DOCKETED	
Docket Number:	24-BSTD-03
Project Title:	2025 Energy Code Compliance Software, Manuals and Forms
TN #:	260645
Document Title:	Andy Llorca Comments - 2025 ACM Workshop Comment - QuietCool
Description:	N/A
Filer:	System
Organization:	Andy Llorca
Submitter Role:	Public
Submission Date:	12/13/2024 3:31:49 PM
Docketed Date:	12/13/2024

2025 ACM Workshop Comment - QuietCool

Subject: 2025 ACM Reference Manuals and 2025 Compliance Manuals Workshop

2025 Single-Family Residential ACM Reference Manual

Figure 4-36: Diurnal Temperature Variation and Ventilation Cooling

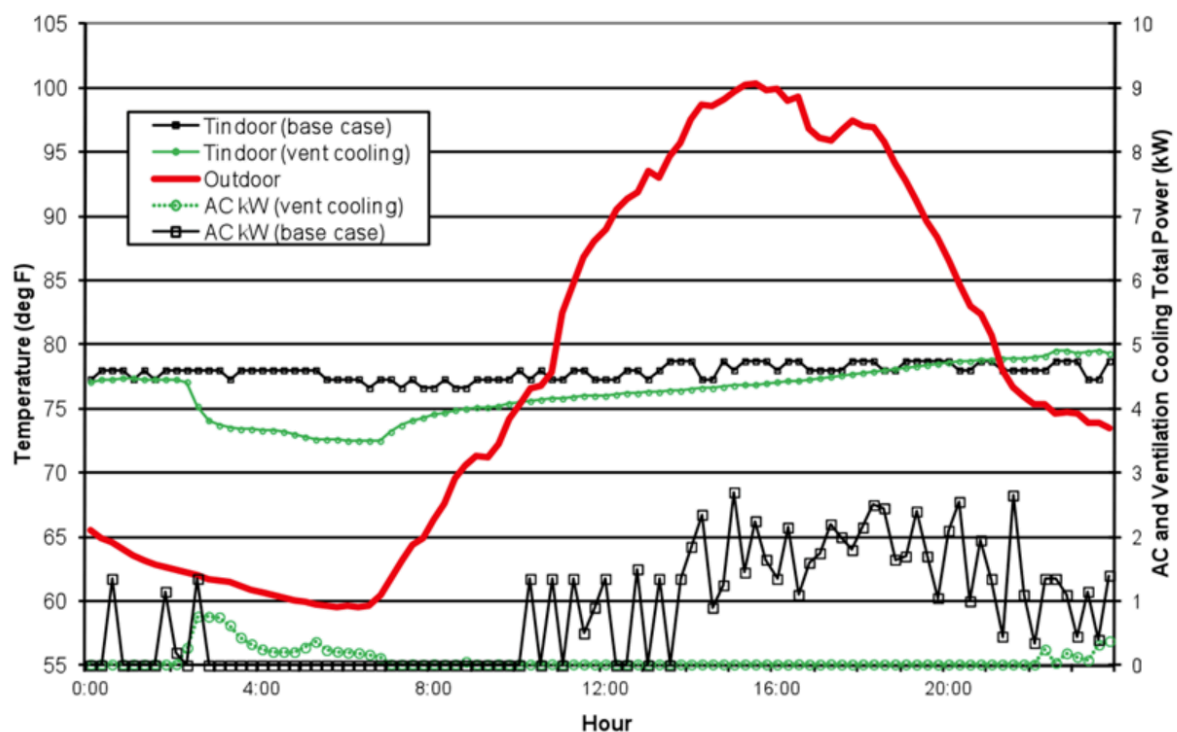
- Reduction of homeowner true cost of ownership, especially in CZ 8-14 hot dry zones.
- Excellent desirability and marketability by builders of new homes.
- Extends the life of HVAC systems by reducing usage.
- Improves solar benefits, by reducing peak cooling loads.
- Improves peak grid consumption for cooling at scale.
- LIHEAP already offers WHF for free because of the impacts to the grid and low income benefits.
- DEER study and CPUC workpapers have deemed WHF extremely beneficial already.
- CBECC functionality and the ACM should be amended to reflect the savings shown in the chart below:

The CEC's own table 4-36 above is evidence of 50-90% kw reduction during WHF operation compared vs the identical home with no WHF.
